Wisconsin Department of Transportation

Proposal #20: 8050-04-70, WISC 2018 324
Siren – Spooner
STH 35 to Viola Lake Road
STH 70
Burnett County

Letting of June 12, 2018

This is Addendum No. 01, which provides for the following:

Schedule of Items

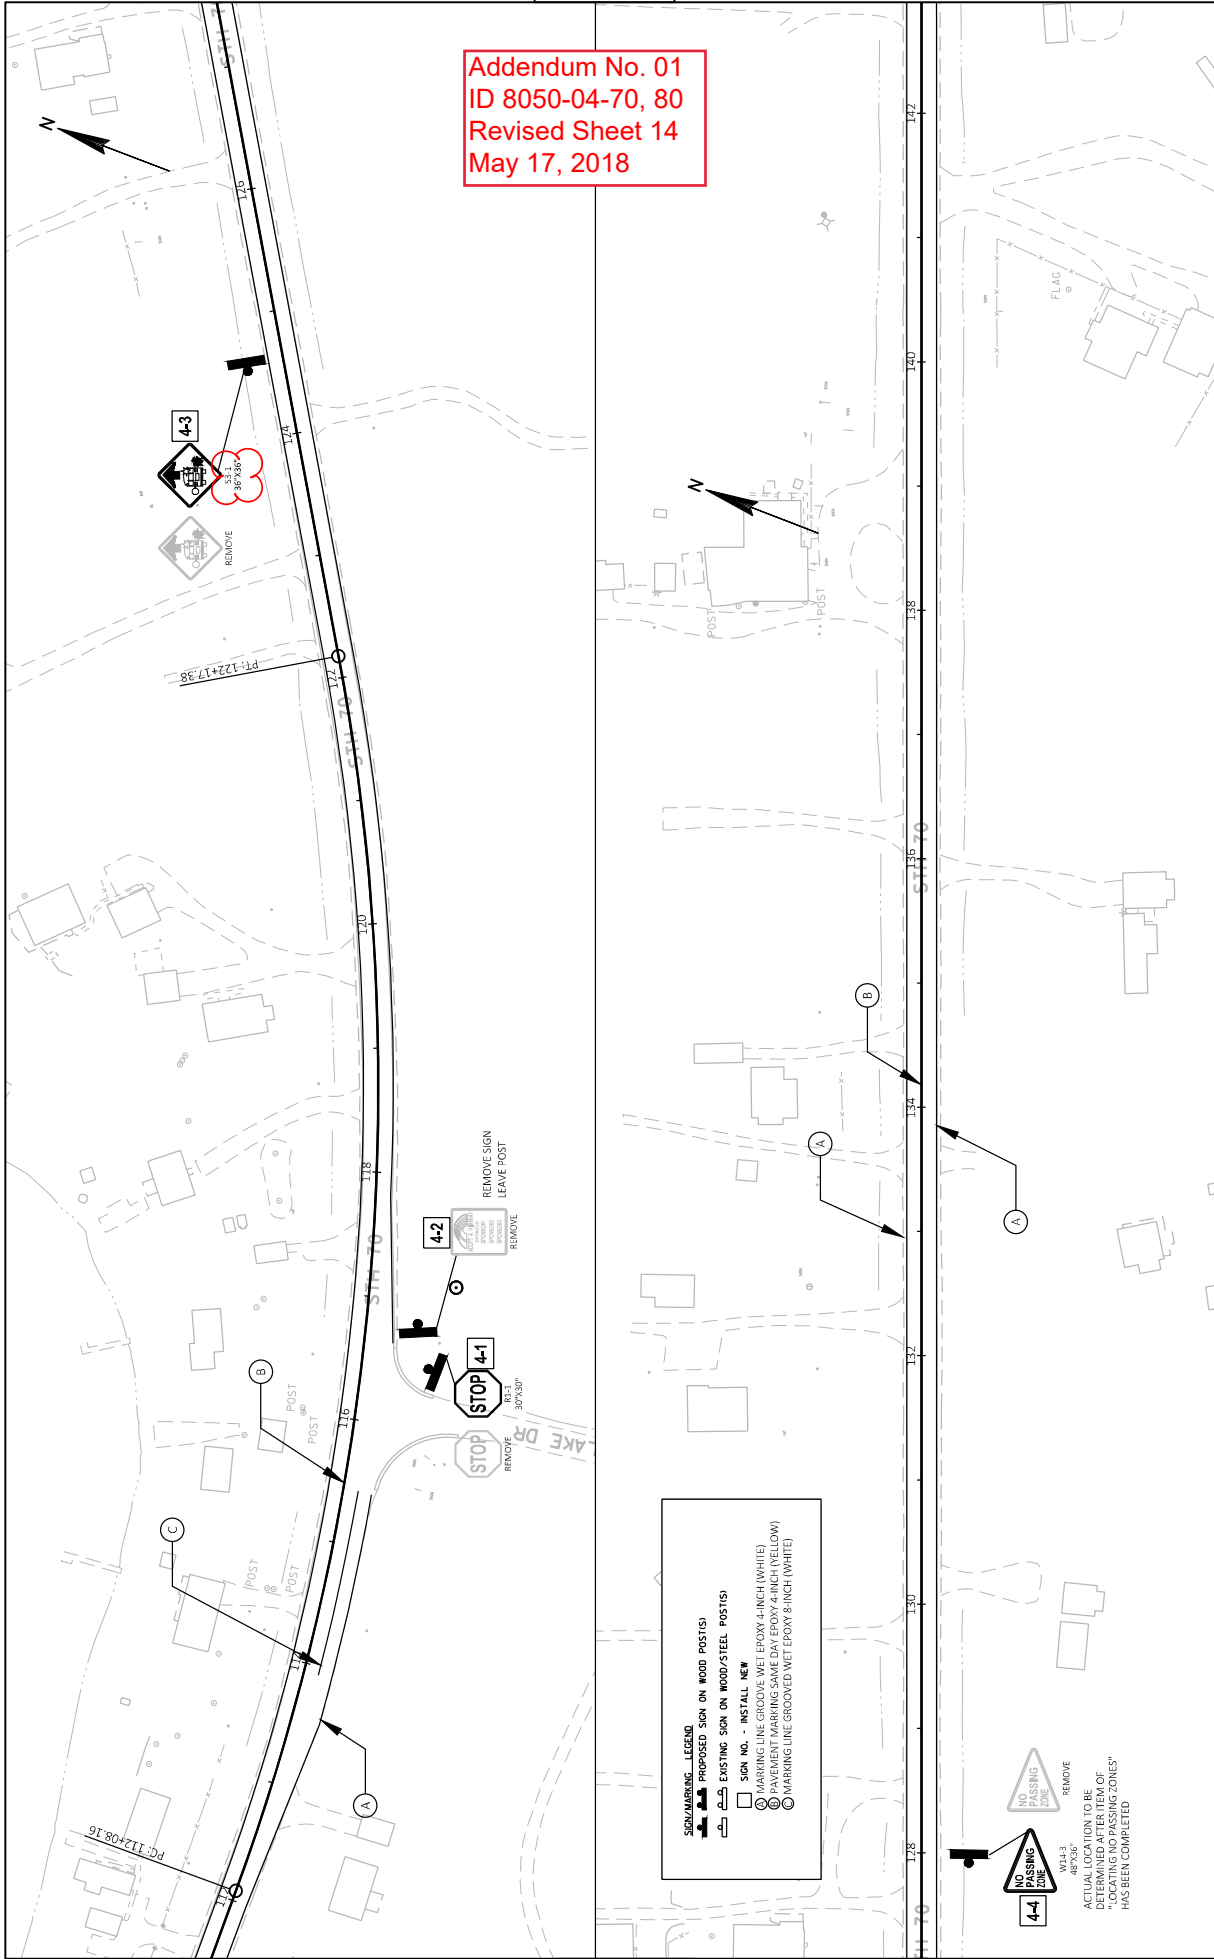
Attached, dated May 17, 2018, are the revised Schedule of Items Page 3.
